# Technical Note

## Southlands Solar Farm FRA Addendum

Project	Southlands Solar Farm FRA Updates
Project Number	P23_174
Title	Southlands Solar Farm FRA Addendum
Description	This technical note aims to address and overcome the objections to the FRA produced for this proposed solar farm development.
Prepared by	Sam Pucknell ( <i>Senior Consultant</i> )
Reviewed by	Brett Park ( <i>Principal Consultant</i> )
Date	23 <sup>rd</sup> June 2023
Version	1.0

This addendum aims to address and overcome the objections received from the Environment Agency (23/00285/FUL 12<sup>th</sup> May 2023).

Figure 1 - 0.1% AEP rerun flood outline vs Flood Zone 2

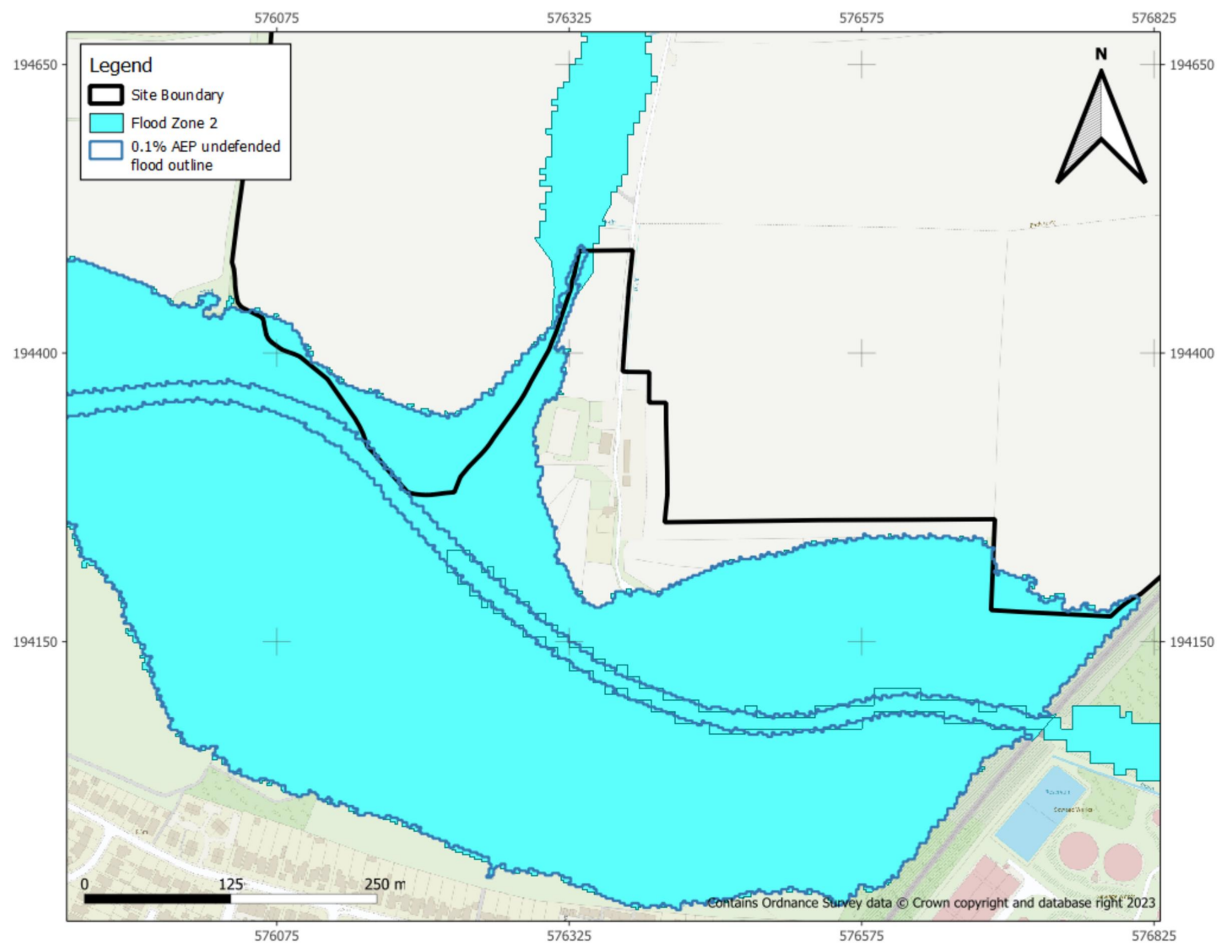
To verify the modifications made to the model are negligible, the 0.1% AEP undefended scenario with no climate change was rerun. As this was used to inform Flood Zone 2 the flood extent should show a good match, see Figure 1. The flood extent overlaps with a very minimal difference in border thus demonstrating that the changes made have had a negligible impact at the location of interest.

Figure 2 - 1.0% AEP + 38% climate change max flood depths (defended)

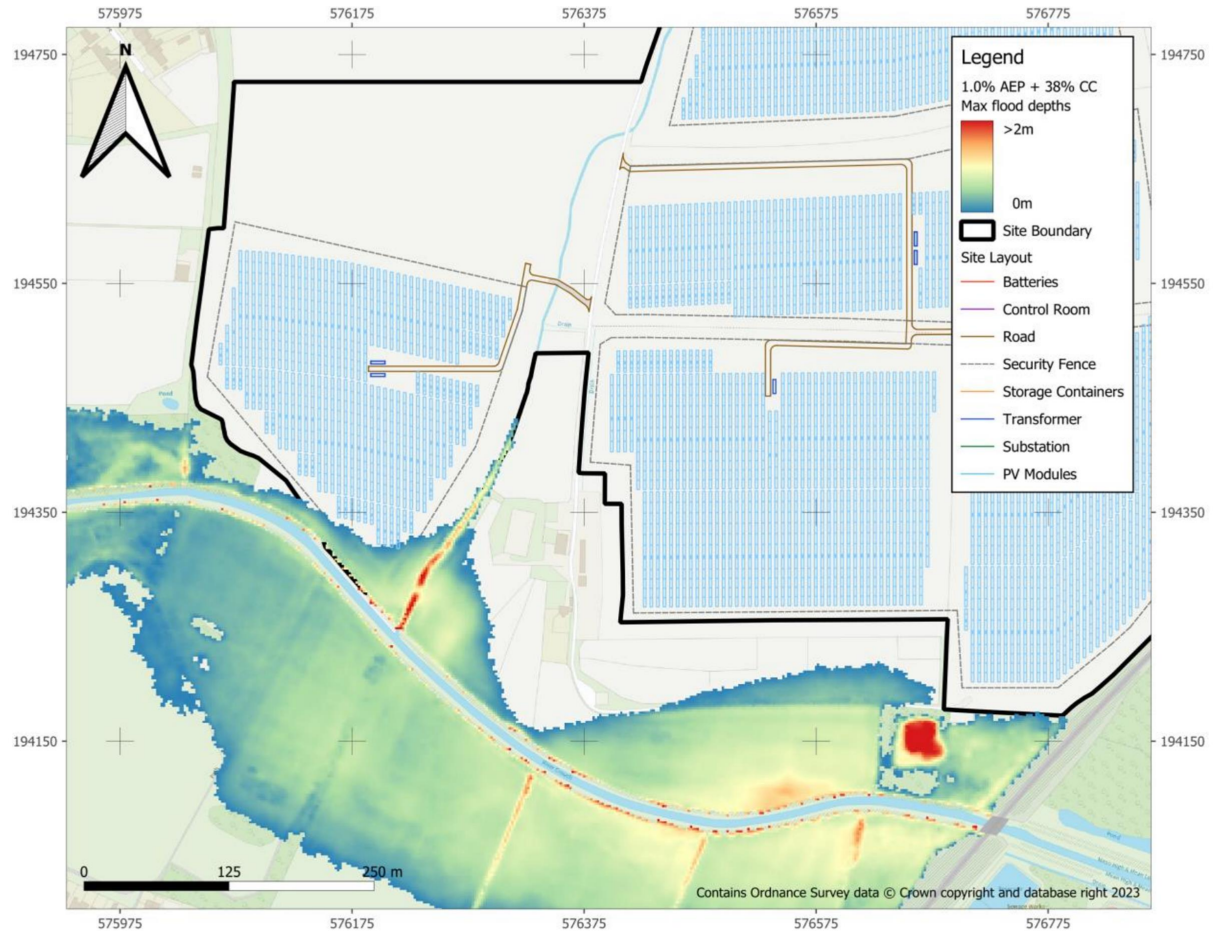
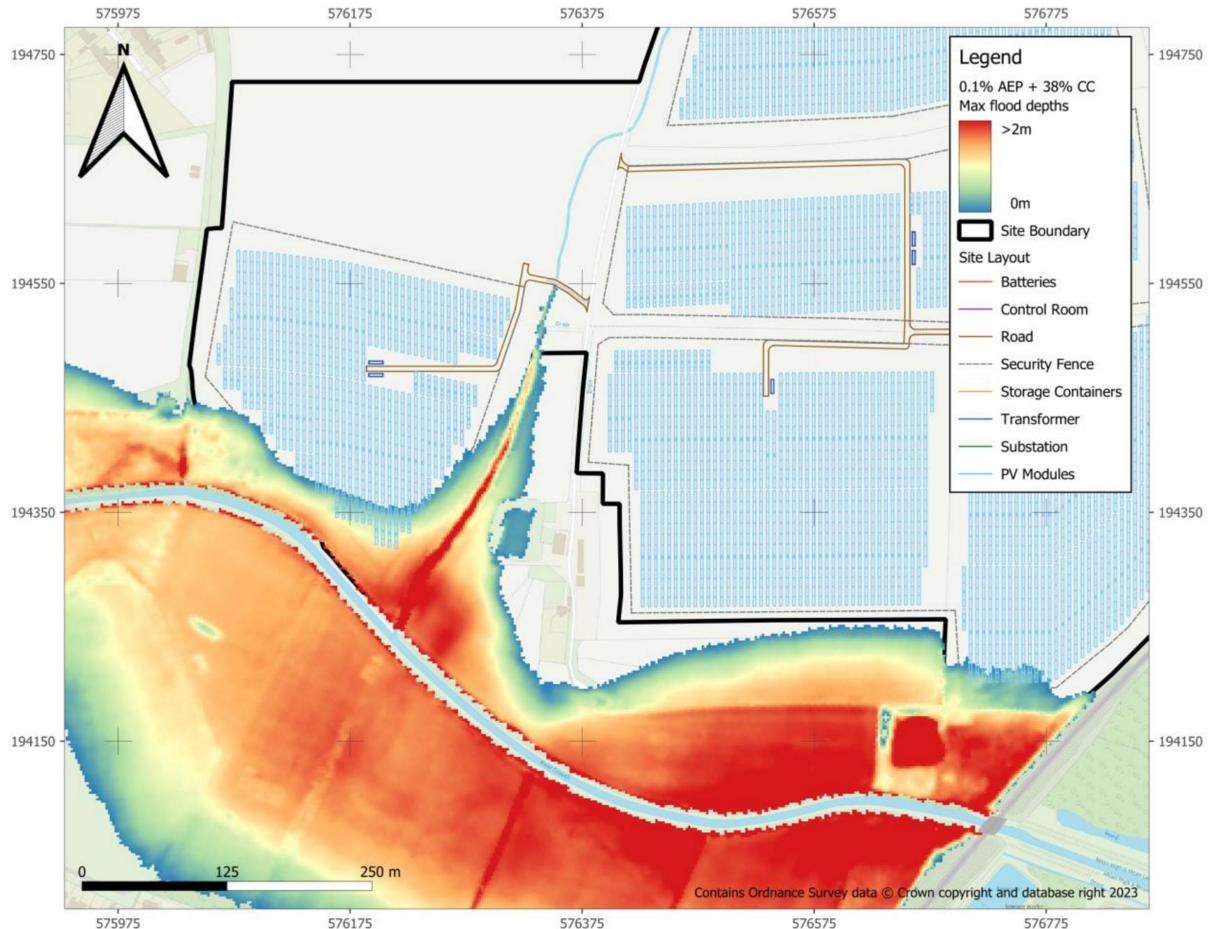
The maximum flood depth within the vicinity of the PV modules on the west side portion of the site is 0.15m. No PV modules are flooded on the east side. Therefore, for this design event the panel stowage height of 2.0m is sufficiently high enough to be above the flood level and provides a freeboard of 1.85m.

Figure 4 – Elevation View of proposed PV Panels

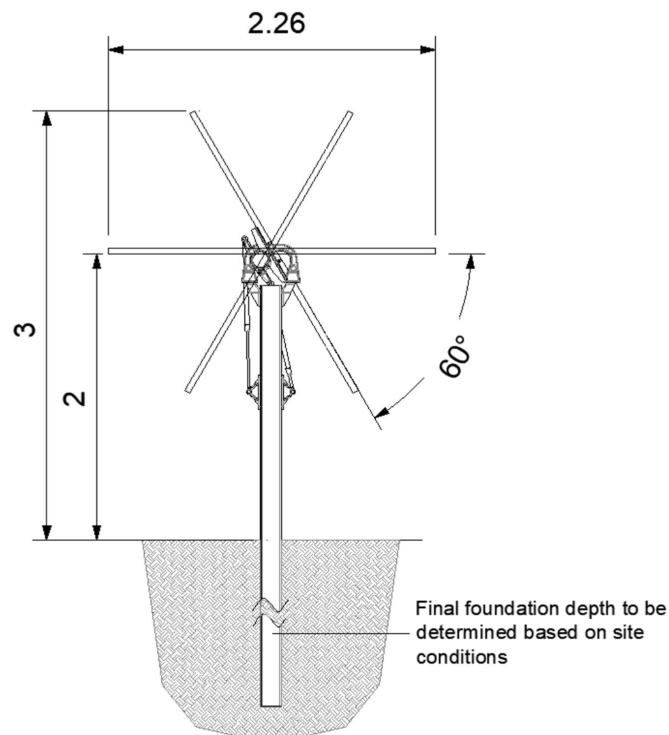
The proposed PV panels will have the ability to rotate around their centre to maximise their efficiency throughout the day. This has the advantage of being able to be stored horizontally as required, providing 2m of clearance above local ground levels, Figure 4.

During extreme flood events the PV panels will be stored horizontally, thus providing the freeboard identified in Section 2.4 and 2.5.
